United States Department of the Interior
OFFICE OF SURFACE MINING
Reclamation and Enforcement
BROOKS TOWERS
1020 15TH STREET
DENVER, COLORADO 80202

**PRICE RIVER MINE COMPLEX
TECHNICAL AND ENVIRONMENTAL ASSESSMENT**

TECHNICAL AND ENVIRONMENTAL ASSESSMENT

DRILL HOLE MC-6

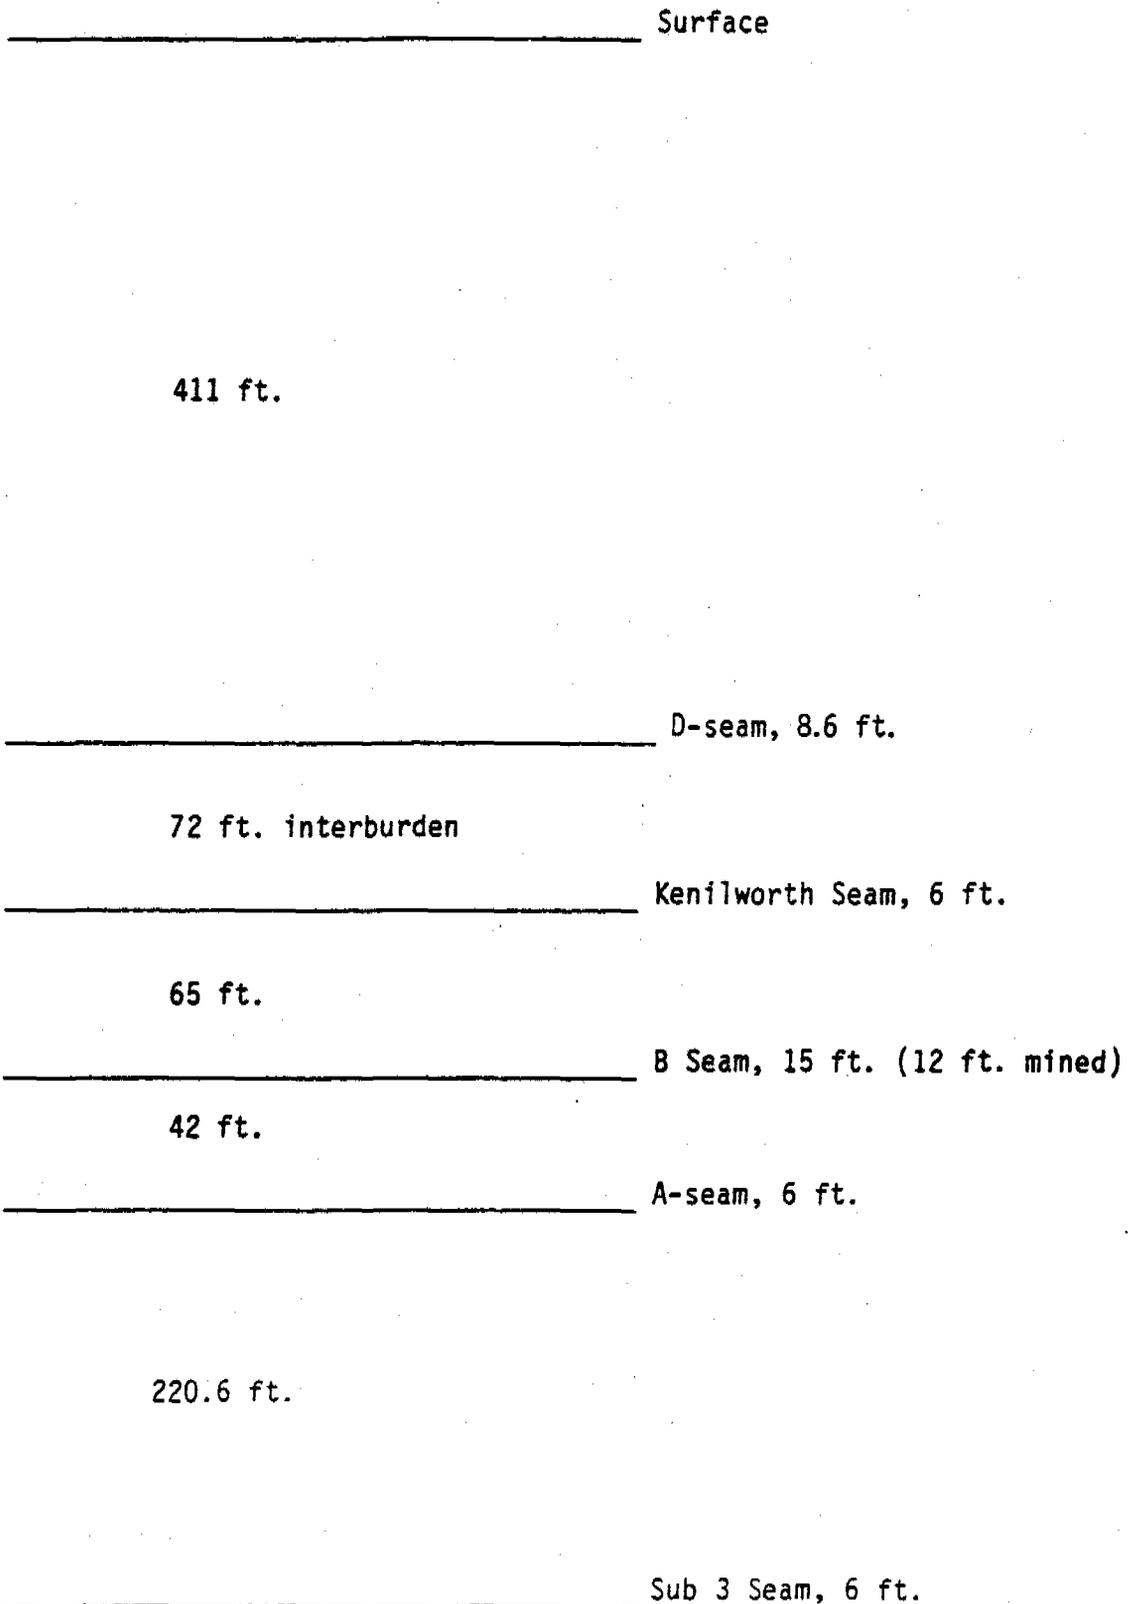
Although this hole was not drilled through the Aberdeen to the Sub 3 Seam, the occurrence of the Aberdeen is very consistent throughout this area. Detailed lithologic information was submitted for three other drill holes and in each of these holes, the Aberdeen sandstone existed.
